CableLabs[®] Specification Engineering Change Details

EC Identifier: PHYv1.0-N-18.0002-2

Title of EC: Full Duplex Coherent Optics (PHY)

Figure <u>1040 – Dual Optical Interface</u> Transceiver Optical, Electrical and Management Interfaces

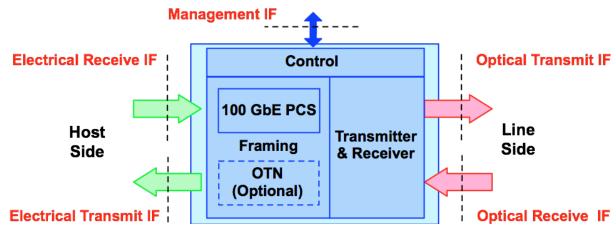
SPEC CHANGE #1	Type of Change: Technical:	EDITORIAL:	BOTH:
SECTION #	TITLE	PARAGRAPH / TABLE # / GRAPHIC #	
5.2	Reference Interfaces	Entire section

The transceiver has multiple interfaces (IFs) that are specified in this document and depicted in Figure 10 Figure 10 and Figure 11. The line-side corresponds to the optical interfaces. The client-side (or host-side) corresponds to the electrical interfaces. In addition, there is a management interface that will be specified in detail in the OSSI specification Error! Reference source not found.

The dual optical interface transceiver option is the transceiver design that has historically been most common, and utilizes separate optical interfaces for transmit and receive functions.

Figure 11– Single Optical Interface Transceiver Optical, Electrical and Management Interfaces

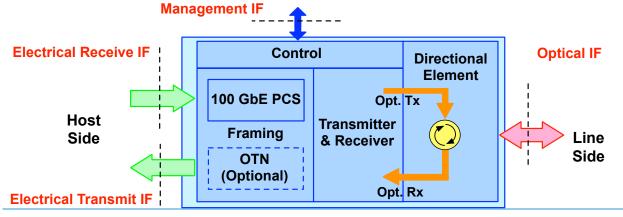
The single optical interface transceiver option addresses the deployment scenarios identified in Section 1.2, where there is only a single fiber available from hub to node. This option incorporates a signal direction function that allows the transmitter optical signal to be directed to the single optical interface and the signal incoming through the single optical interface to be directed to

the receiver with negligible performance impact and while utilizing the same frequency in both directions. The architecture implications when using the single interface transceiver option are described in section 7.6 of [OPT-P2P-ARCH].

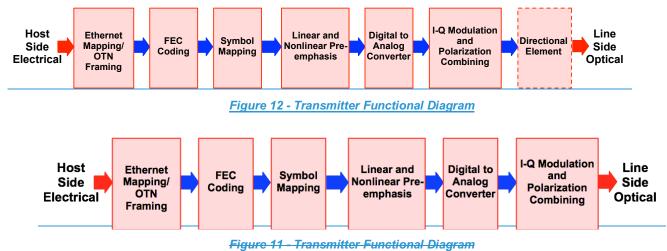
The sequence of key processes that take place in the transmitter as well as the receiver are illustrated in Figure 11Figure 12 and Figure 12Figure 13. The transmitter and receiver process sequences are only provided as examples. Actual transmitter and implementations may follow different sequences and different feedback dependencies.

Figure 11Figure 12 shows functions that take place in the transmitter from the electrical input on the host-side to the optical output on the line-side. The "Directional Element" block on the line side is only applicable to the single optical interface transceiver option.

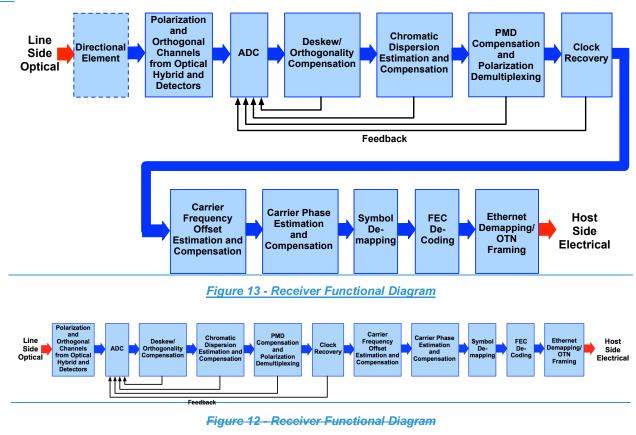
Figure 12 Figure 13 shows the functions that take place in the receiver from the optical input on the line side to the optical output on the host side. The "Directional Element" block on the line side is only applicable to the single optical interface transceiver option.
